## PLANNING DIVISION STAFF REPORT

**Project Name/Address:** 1239 Spaight

**Application Type:** PUBLIC HEARING  
Demolition and new construction in the Third Lake Ridge Historic District

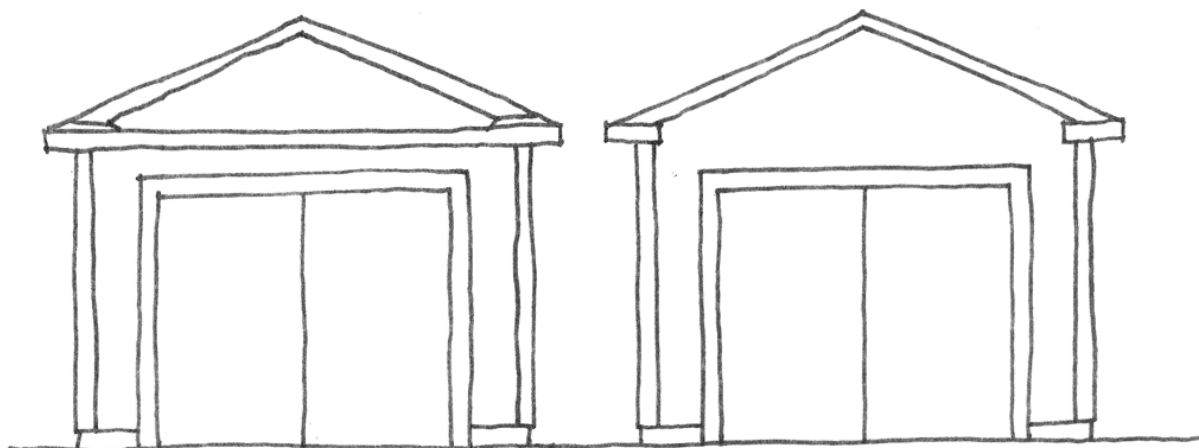
- (d) Please review discussion of (h) below.
- (e) The proposed building has a gabled roof which is similar to the roof forms present on numerous buildings in the area of visual compatibility and to the roof of the primary building although the pitch is lower than the roof pitch of the primary building. In addition, the elevation drawing shows a closed pedimented gable form which should be simplified to remove the horizontal eave and allow the soffit and fascia to return up the gable at an angle.

1. If operable windows are desired, the proposed windows shall be changed to awnings of similar appearance or to one over one double hungs. The fixed windows in the doors can remain as proposed.
2. The siding shall be changed to not include faux wood grain.
3. The gable roof form shall be simplified by removing the pedimented gable.
4. The roof material shall be changed to asphalt shingle.
